Agenda  
Lane Cove Local Planning Panel Meeting  
19 November 2024

**Lane Cove Local Planning Panel Meeting 19 November 2024  
2 EDWIN STREET, GREENWICH.**

**Item No:** LPP10/24  
**Subject:** 2 Edwin Street, Greenwich.  
**Record No:** DA24/90-01 - 71886/24  
**Division:** Planning and Sustainability Division  
**Author(s):** Andrew Bland

<b>DA Number</b>	<b>Council Reference:</b> DA90/2024 <b>Portal Reference:</b> PAN-443779
<b>Proposed Development</b>	Demolition of existing structures and construction of a two storey dwelling house.
<b>Street Address</b>	2 Edwin Street, Greenwich
<b>Applicant/Owner</b>	<b>Applicant:</b> BJ Architects International Pty Ltd <b>Owner:</b> S Zhuang
<b>Date of DA Lodgment</b>	9 September 2024
<b>Development Cost</b>	\$1,000,000.00
<b>Public Notification Period</b>	<b>Notification Period:</b> - 9 September 2024 to 25 September 2024 In accordance with Council policy, the amended design was not required to be notified as the impacts were reduced.
<b>Submissions Received</b>	7 unique submissions have been received by way of objection. 1 submission was held by way of site meeting.
<b>Recommendation</b>	<b>Approval</b>
<b>Local Planning Panel Referral C

**Figure 3: Dwelling houses subject to view impacts (Source: Council Planner)**

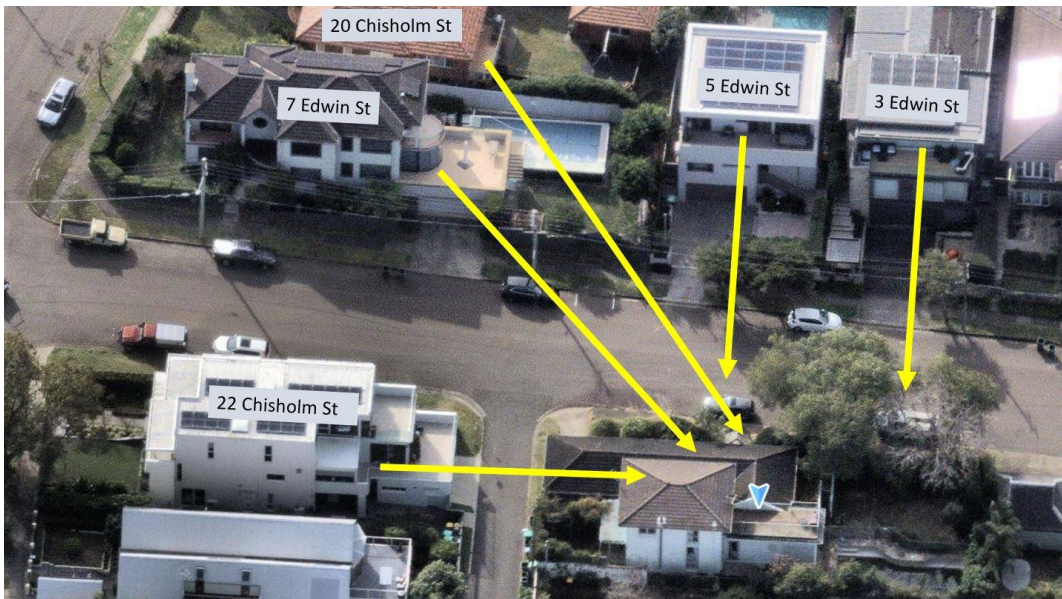
Upon completion of the initial site inspection, it was concluded that other properties would also be subject to view impacts as identified in **Figure 3** and **Figure 4** below. Council requested that height poles be erected in accordance with an alternate design solution. This solution sought to address the concerns raised in the RFI and to enable a complete assessment of view impacts for all the impacted properties.

This included the exploration of a view corridor between the proposed dwelling and existing vegetation to benefit 20 Chisholm Street and 7 Edwin Street. The height poles were erected for a design which varied Council's DCP front setback control (moved the development closer to Vista Lane).

**Figure 5: Height poles with minor discrepancies (Source: Council Planner.)**

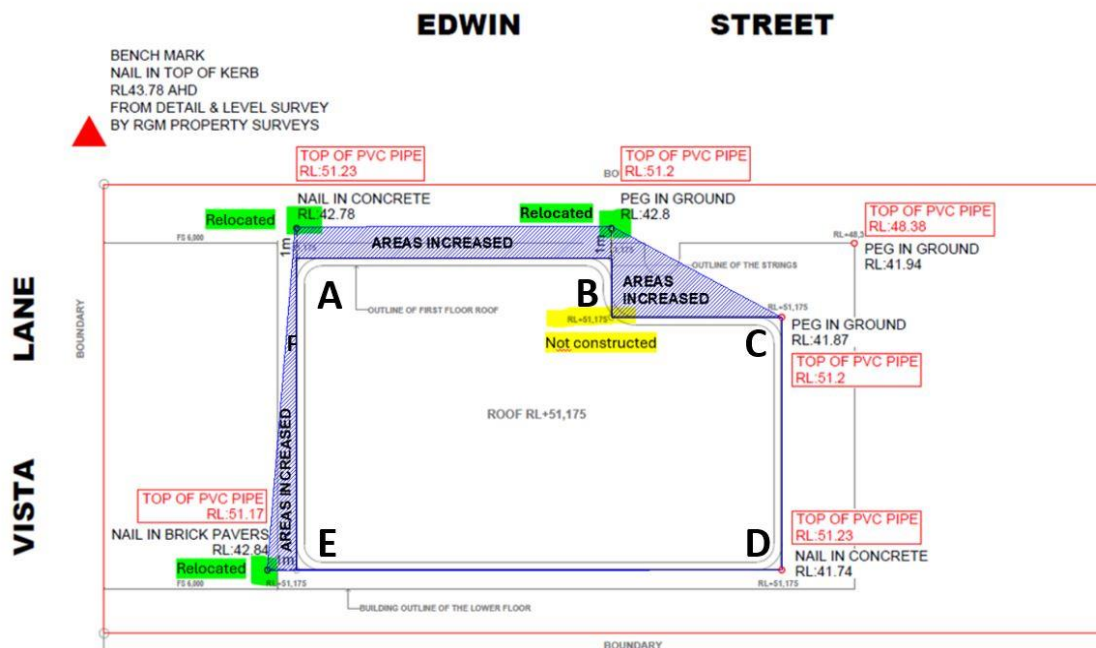
Additional height poles were erected on 30 October 2024 and certified by Matthew Plowman from SDG Pty Ltd. Due to high winds the string lines were not attached, and the heights varied slightly from the proposal. The certified heights and a clarification on the location of the poles is provided in **Figure 5** below. Some of the height poles were erected up to 550mm higher than the original design which marginally accentuated the view loss impacts.

The height discrepancies are identified as:

A - 550mm higher, B - 250mm higher, C - 250mm higher, D - 550mm higher, and E - 50mm lower.
